DETAILS

105 N. Hallett Street

Extend and modify existing attached carport

Old Dauphin Way

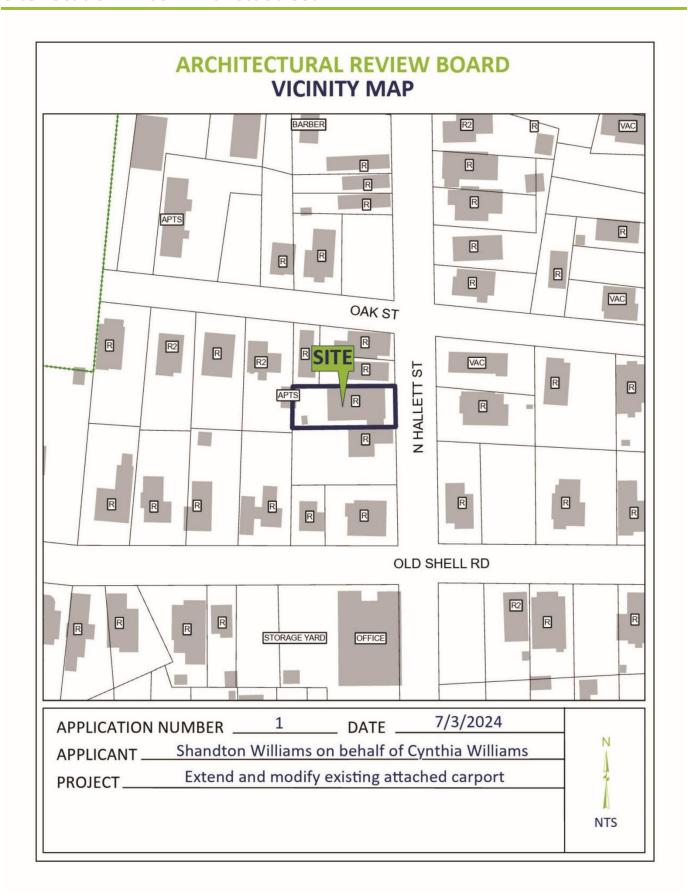
- a. An addition which matches the existing carport would extend to the west and would measure 10'-0" wide by 22'-0" deep, adding 220sf to the existing carport, for a total of 440sf.
- b. A new metal or shingle shed roof would replace the existing and extend over the addition.
- c. The five (5) existing wood posts would be replaced, and seven (7) additional posts would be installed to support the new roof extension. Posts would measure 4'x4".
- d. The ceiling height would measure 8'-6".
